Shippensburg University

SUPPLEMENT 1 Electrical Coordination Study

Professional:
Entech Engineering, Inc.
4 South Fourth Street
P.O. Box 32
Reading, PA 19603
Telephone: 610-373-6667
Fax: 610-373-7537
www.entecheng.com
Entech Project #: 2184.22

August 24, 2004

TCC Name: TR1-3 HENDERSON GYM
Rev. 0.0
Date: March 12, 2004

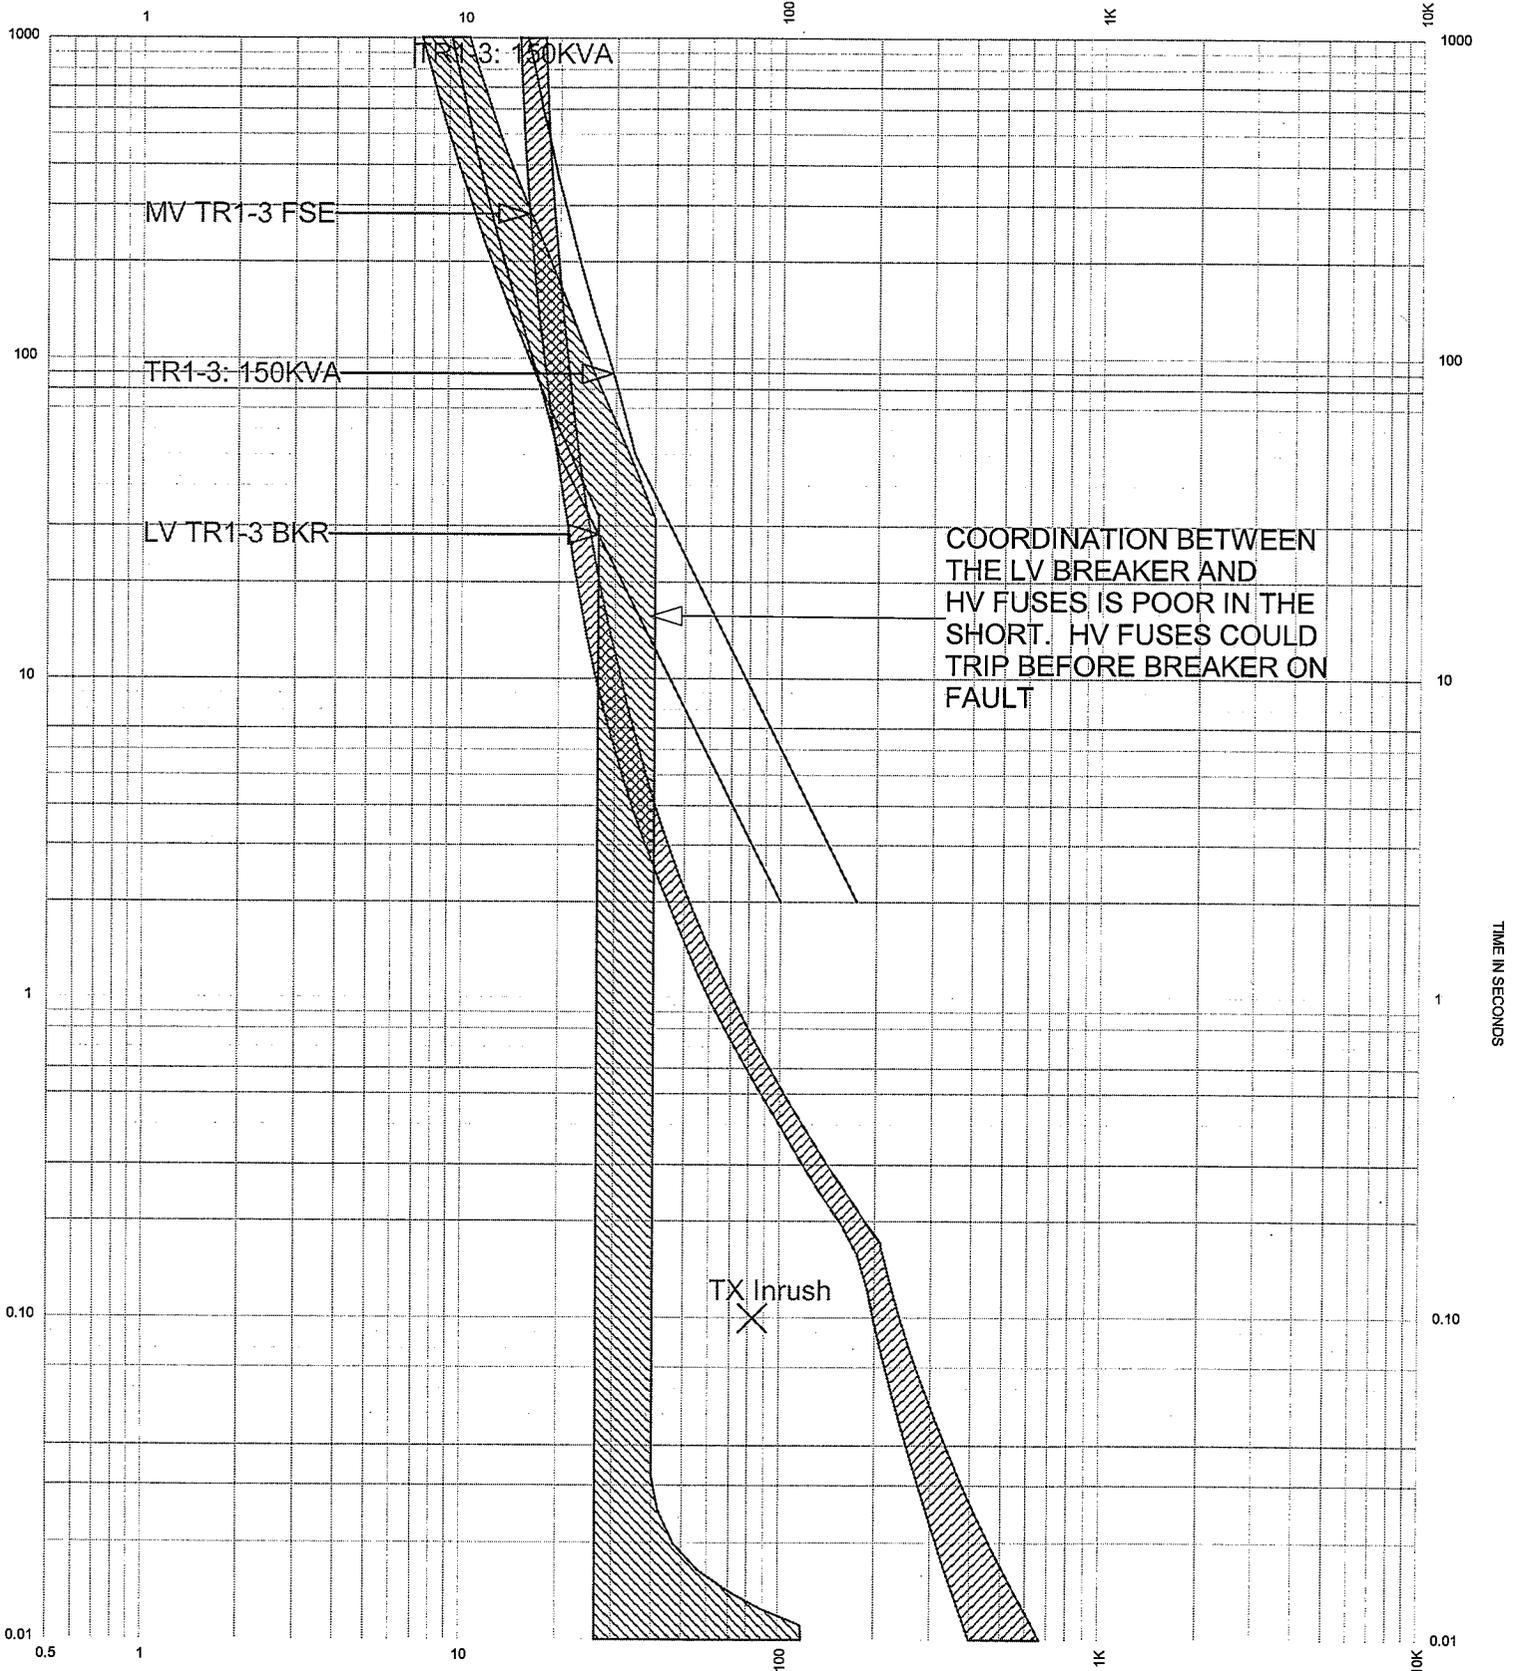
TCC TR1-3 Henderson Gym: The existing low voltage secondary main breaker is not coordinated with the primary fuse. To improve coordination, the existing thermal magnetic breaker could be replaced with a static trip (solid state) main breaker with long-time, short-time, and instantaneous pickup and delay settings.

TCC Name: TR1-9 TENNIS & MULTI-USE
Rev. 0.0
Date: March 12, 2004

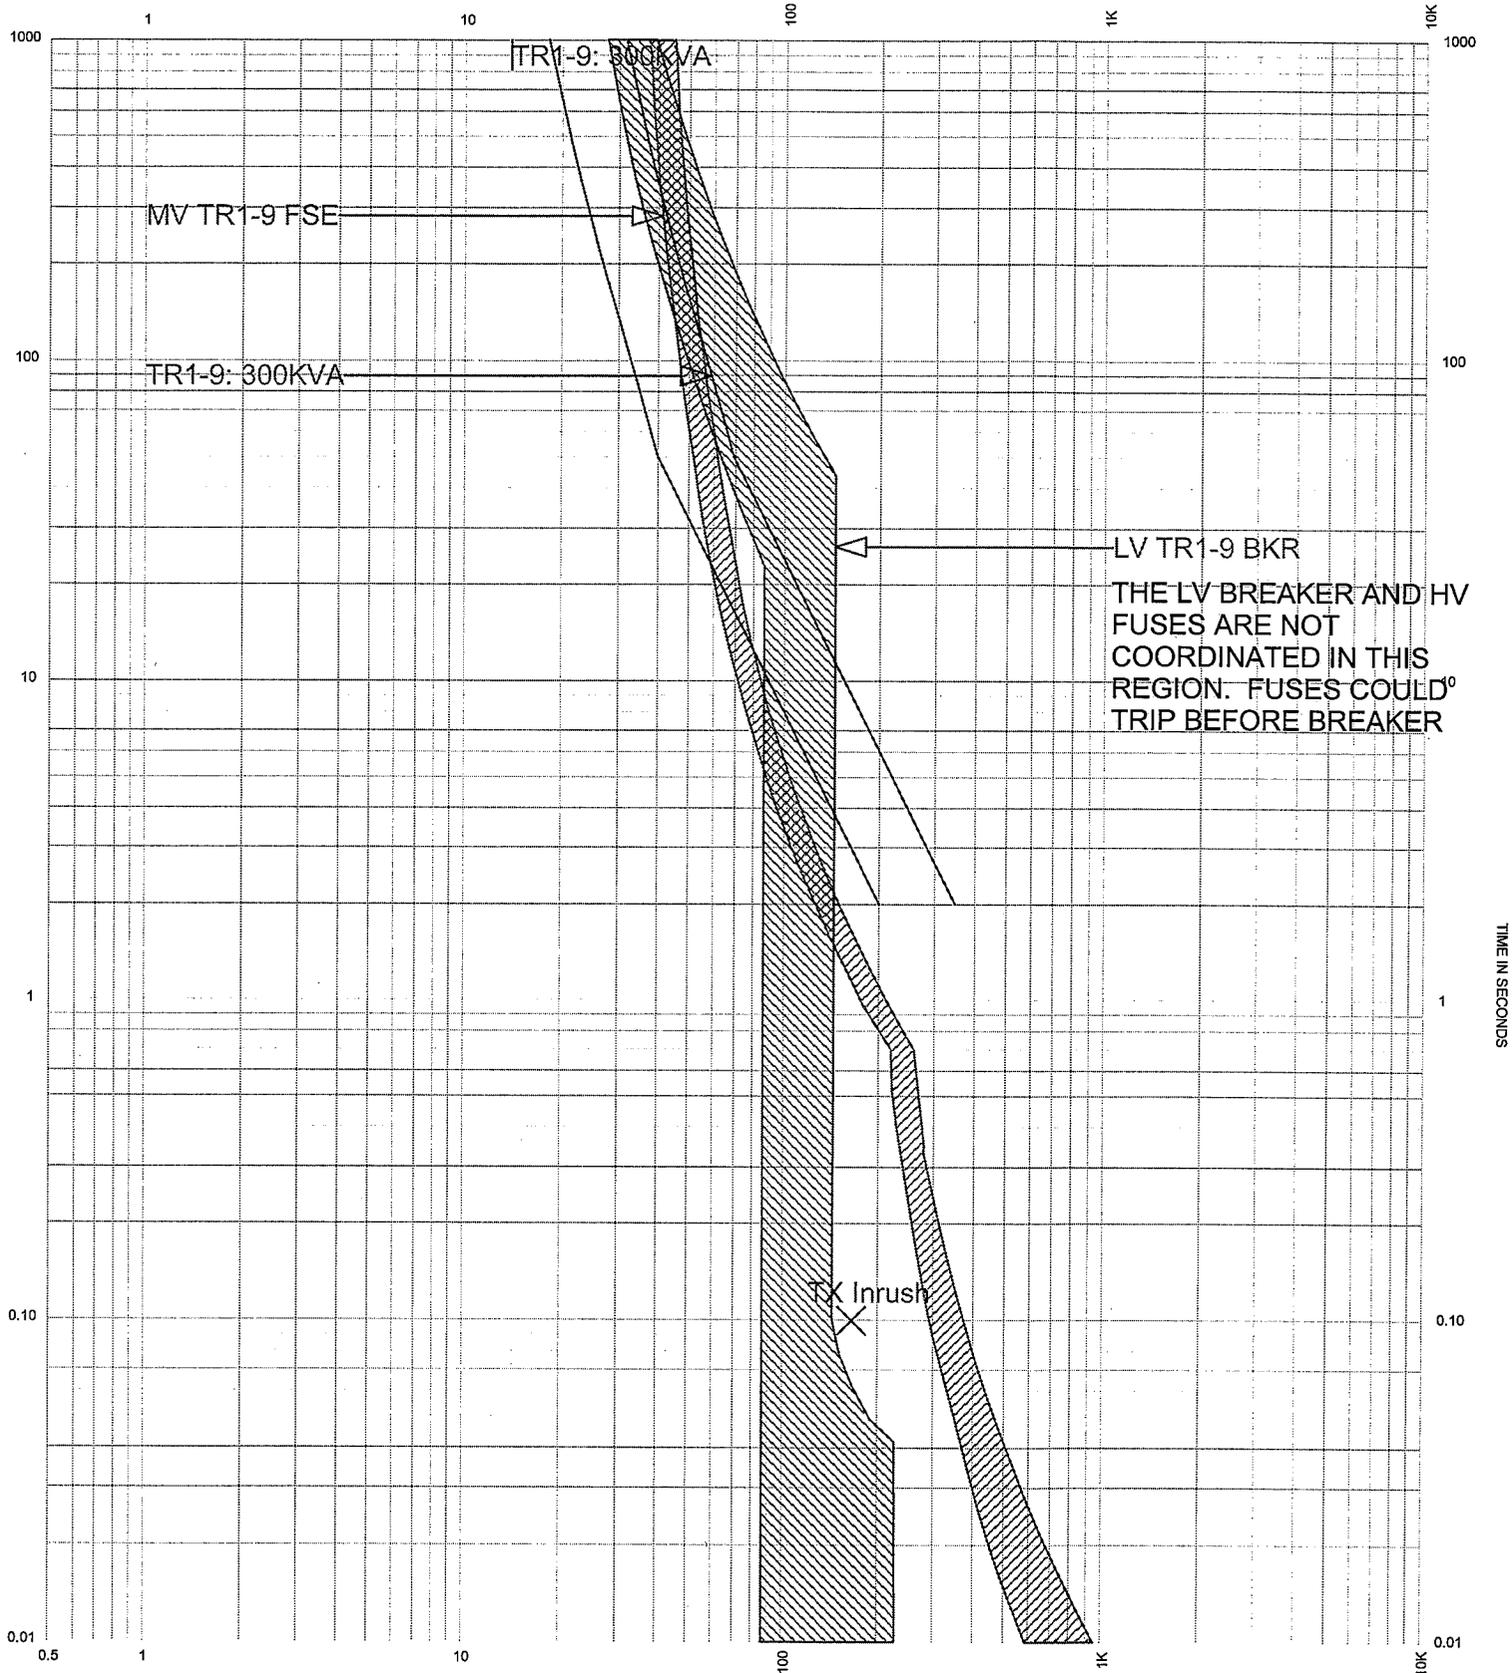
TCC TR1-9 Tennis Courts and Multiuse Field: The existing low voltage secondary main breaker is not coordinated with the primary fuse in the short time region. Coordination could be improved by replacing the existing secondary main breaker with a static trip (solid state) main breaker with long-time, short-time, and instantaneous pickup and delay settings.

TCC Name: TR1-10 SHEARER & ROWLAND
Rev. 0.0
Date: March 12, 2004

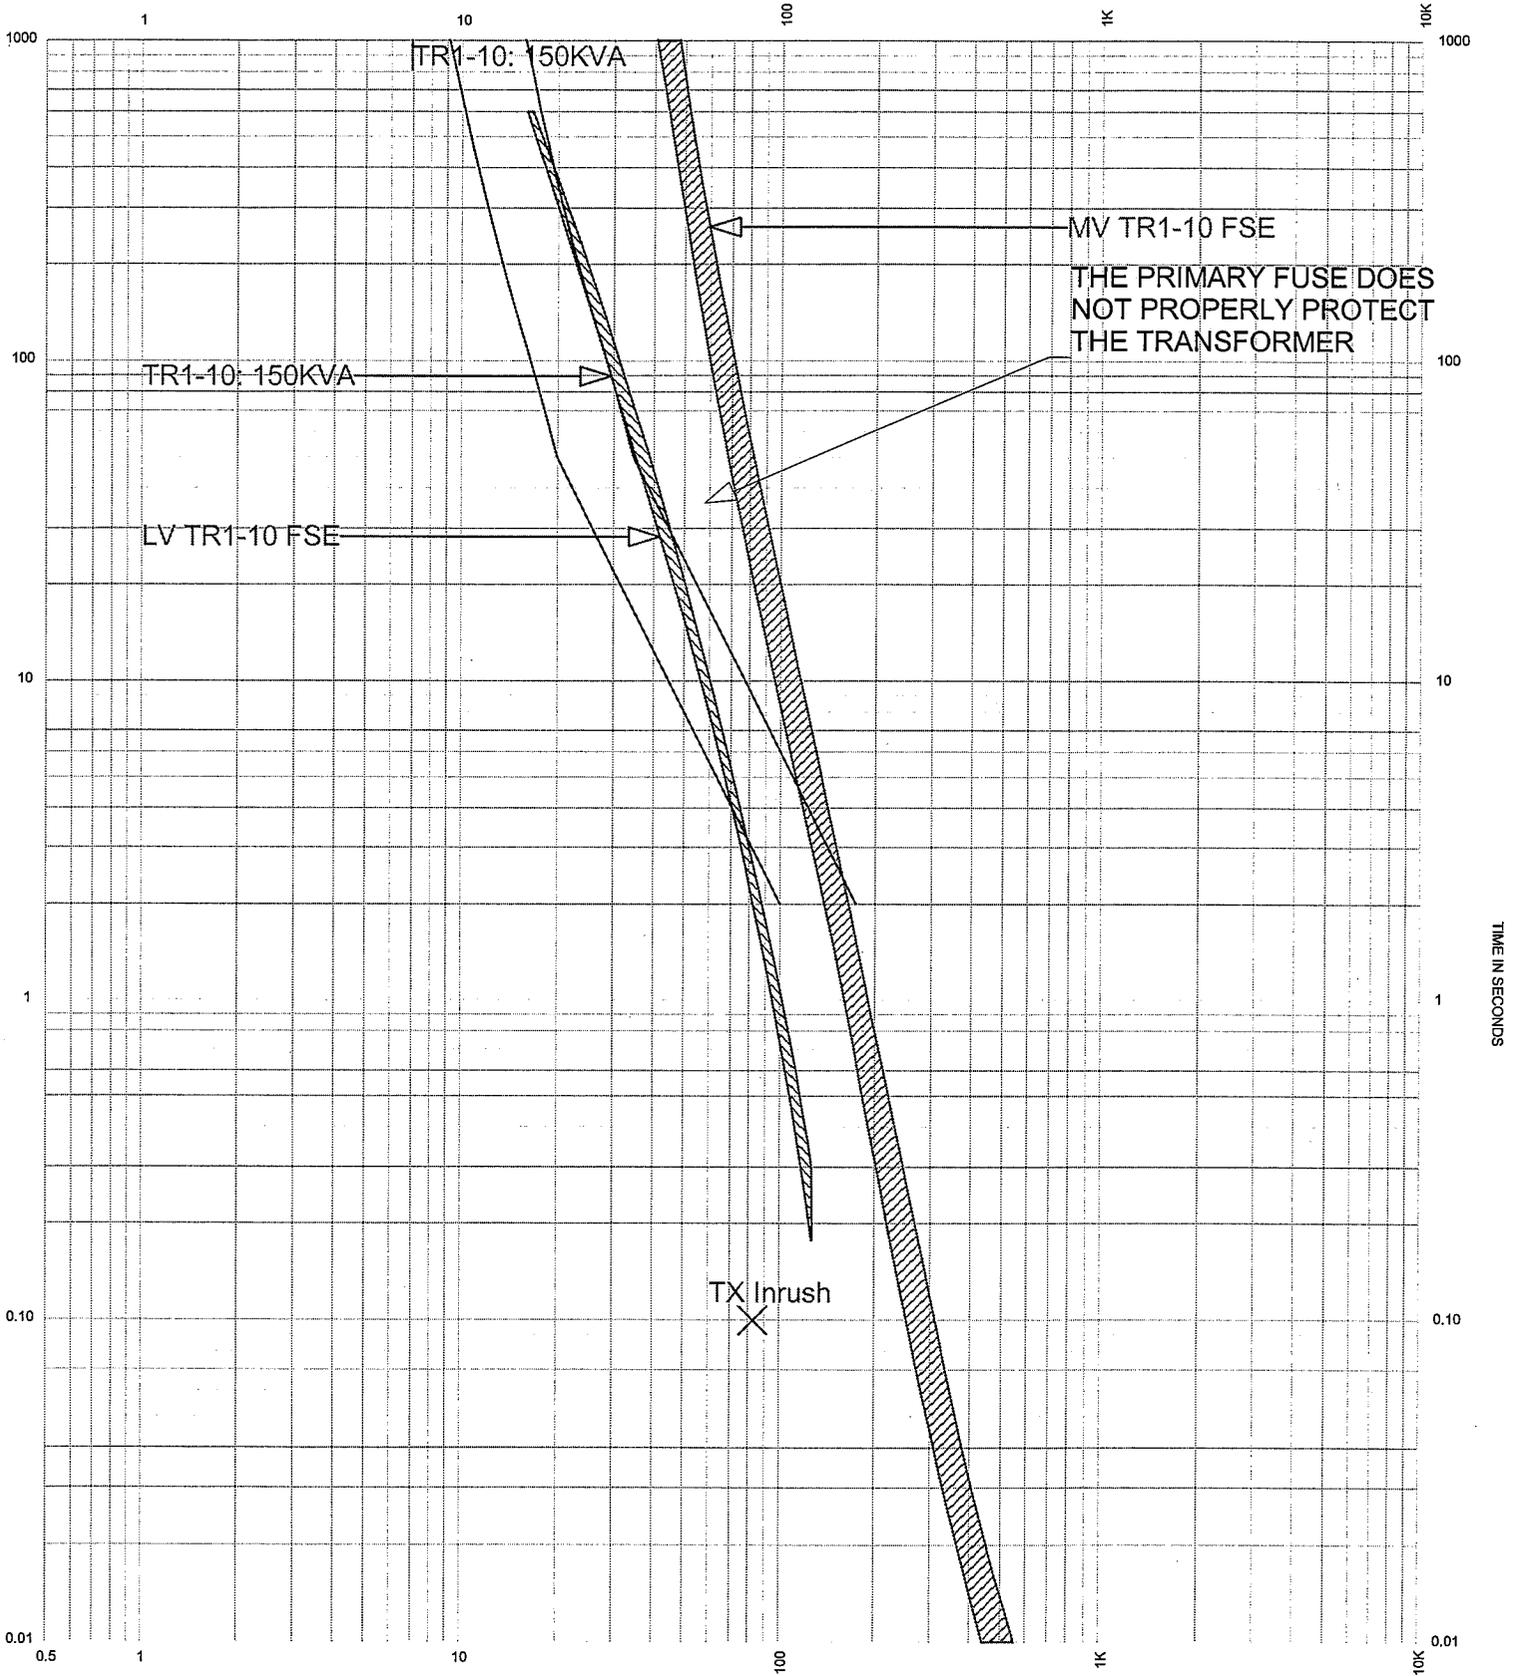
TCC TR1-10 Shearer and Rowland: The existing C rated 20A primary fuse does not properly protect the transformer TR1-10. According to University personnel, the service for Rowland and Shearer Halls is being redesigned at this time. It is recommended that the primary protection for the new service be selected to adequately protect the transformer. The new secondary of this service should be provided with a static trip (solid state) main breaker with long-time, short-time, and instantaneous pickup and delay settings to provide greater flexibility in coordinating with the upstream devices.

TCC Name: TR2-4 WRIGHT HALL
 Rev. 0.0
 Date: March 12, 2004

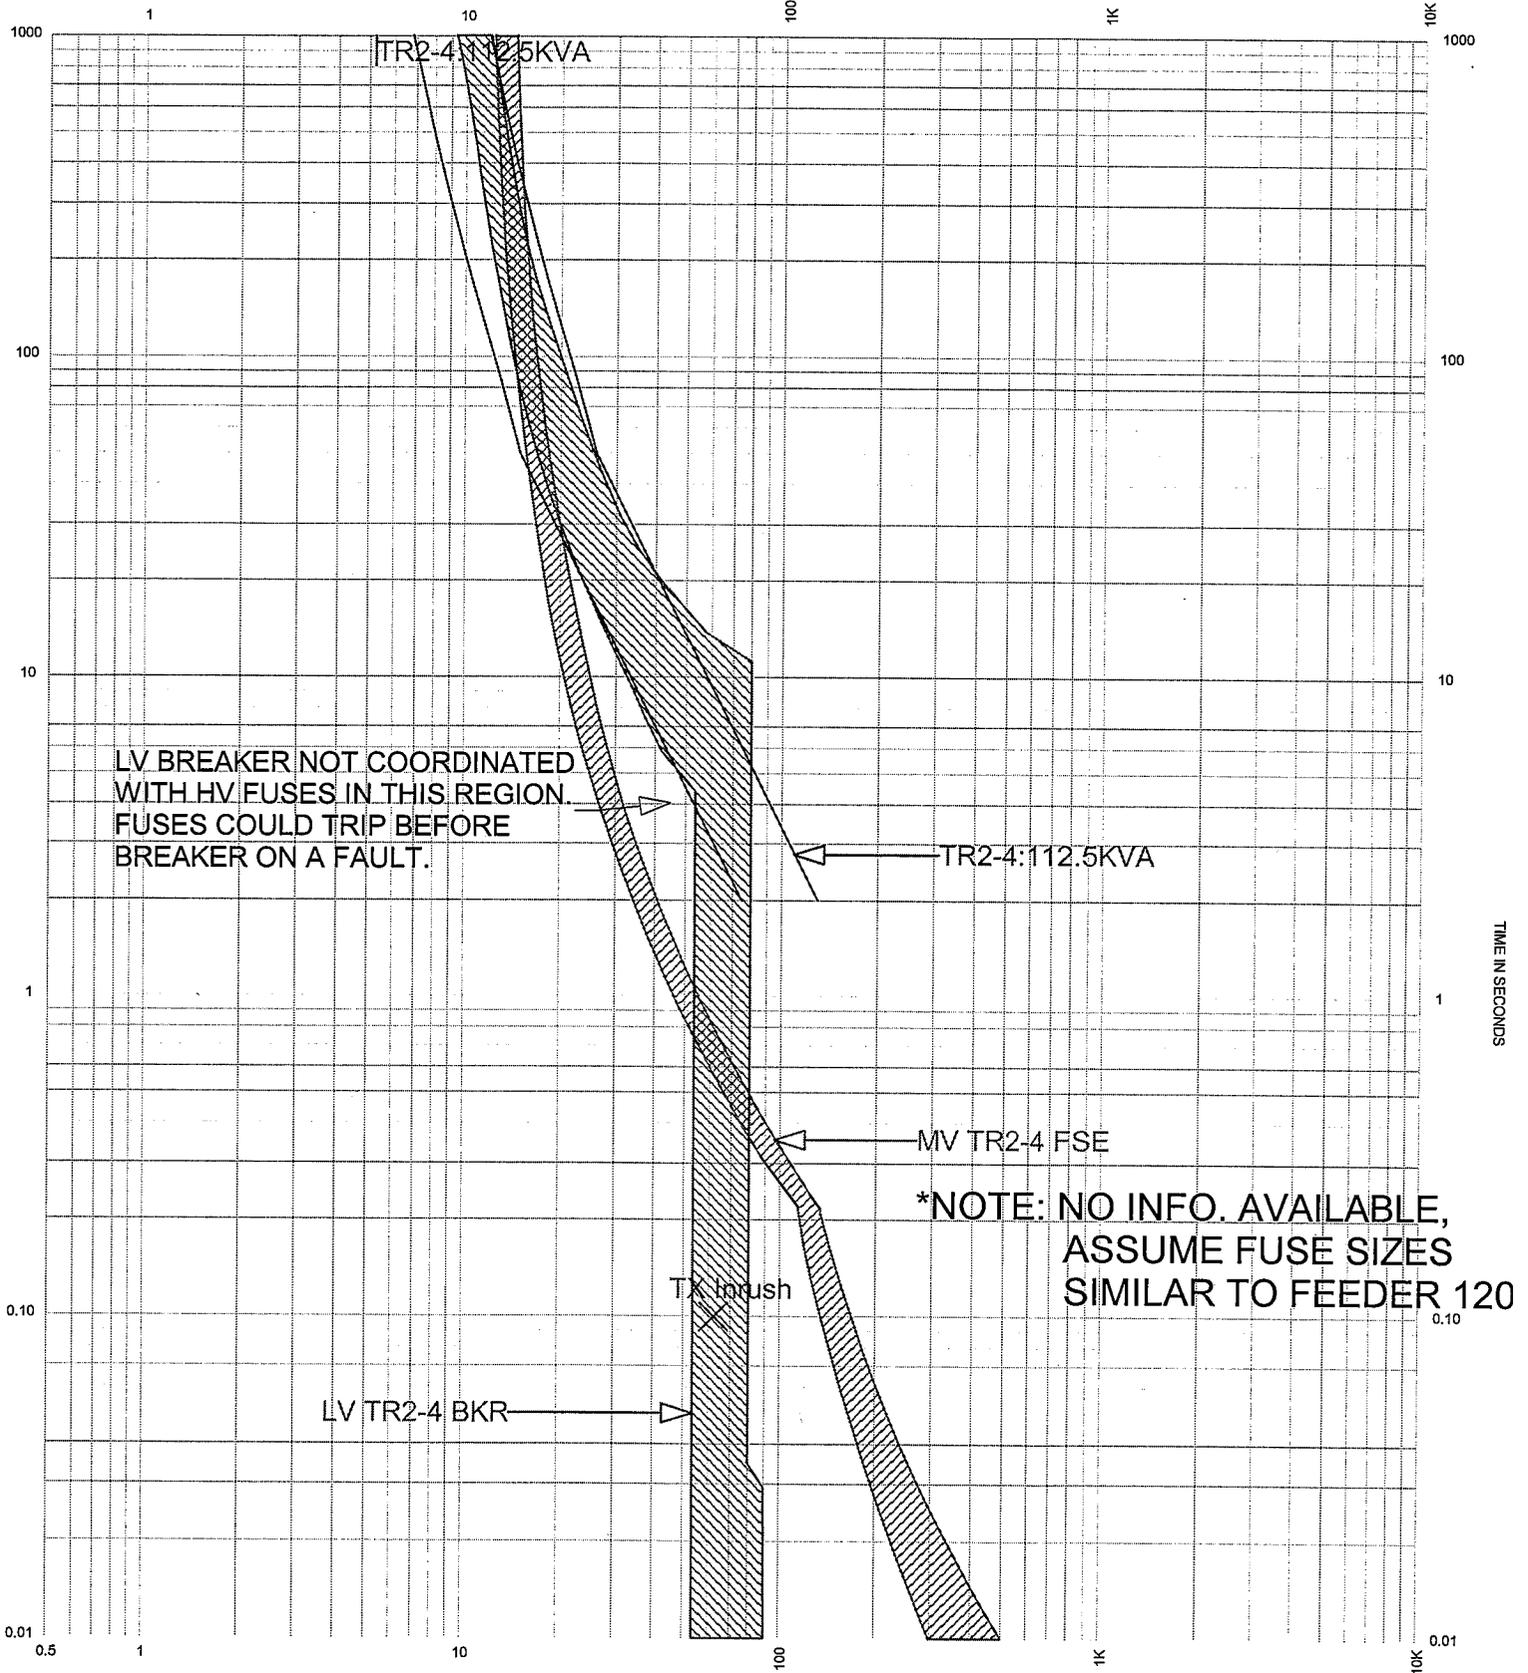
TCC TR2-4 Wright Hall: The existing low voltage secondary main breaker is not coordinated with the primary fuse in the short time region. Replacement of the secondary distribution panel should be considered based on age and configuration. A new static trip (solid state) secondary main breaker with long-time, short-time, and instantaneous pickup and delay settings is advised. This would allow greater flexibility in coordinating with the upstream primary fuses.
